## **SILVER PINES SUBDIVISION**

APPLICATION NUMBER 11 DATE February 15, 2007

# DETAIL SITE PLAN

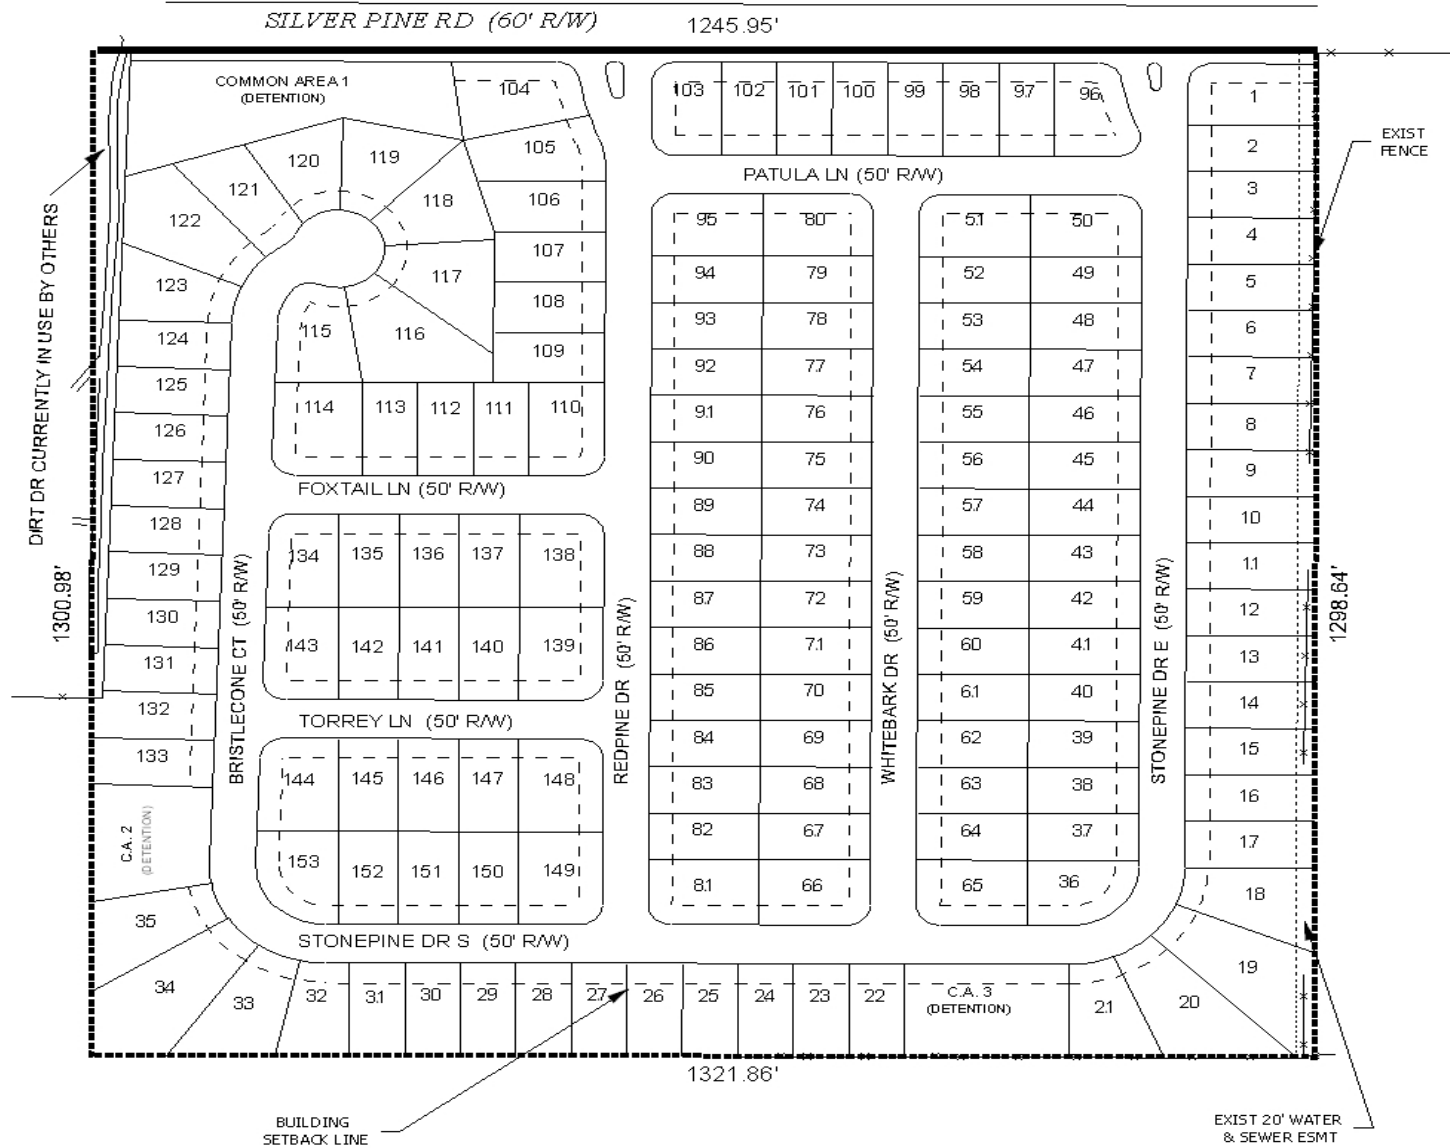
The application involves the creation of new streets, street stubs, turnarounds, and traffic calming devices, which should be constructed and dedicated to County Engineering standards. The southern street stub should adjoin the Dawes Creek Subdivision street stub, as shown on the plat.

Detention and common areas are shown on the plat, labeled accordingly, and accompanied by a note on the final plat stating that their maintenance will be property owners' responsibility. However, there are two islands located at the entrances to the subdivision which are not labeled as common areas. The county does not accept maintenance of such islands, therefore they should be labeled as common area.

It should also be pointed out that there is a portion of the site that is neither a lot nor a common area, but is simply noted as “DIRT DRIVE CURRENTLY IN USE BY OTHERS”. While it is used by others, it is apparently part of the parcel in question and must have some formal designation. There may also be some question about this area either being considered a prescriptive right-of-way, or even being adversely possessed by the adjacent property owners. This issue should be resolved prior to approval.

The site abuts a street stub to the West (Maple Valley Road South), and should provide a connection to that street stub when Maple Valley Road South is constructed to County Standards. Additionally, a street stub should be provided to the large undeveloped tract adjacent to the East. While this tract has frontage on both Silver Pine Road and Schillinger Road North, the provision of a street stub would allow an additional access to Schillinger when that site is developed, as well as allow for future connectivity from Schillinger Road to Howells Ferry Road.

Based on the preceding, it is recommended that this application be heldover until the March 15 meeting to allow the applicant to revise the plan and illustrate the following:

- 1) revision of the dedication along Silver Pine to reflect 20' from centerline;
- 2) resolution of issues relating to the “DIRT DRIVE CURRENTLY IN USE BY OTHERS”;
- 3) provision of street stubs to the East and West;
- 4) labeling of the islands as common areas;
- 5) illustration of proposed phasing of the subdivision
